Product Upgrade

Improved SH 325 series

As a part of this process we have decided to improve SH 325 series chains by equipping them with the same pin used in the Rexnord 820 Series TableTop[®] chains.

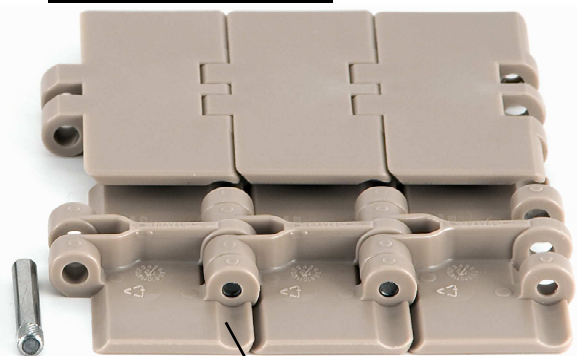
SH325 Classic design

Classic Hole

Cylindrical knurl type

SH325 New design

Blind Hole

Helical knurl type

Old and new chains can be coupled, but please make sure to only use new design pins with new design links and old design pins with old design links. Old and new design will run on the same sprockets and tracks. The new design will result in better performance at high working loads, all the other characteristics remain the same.
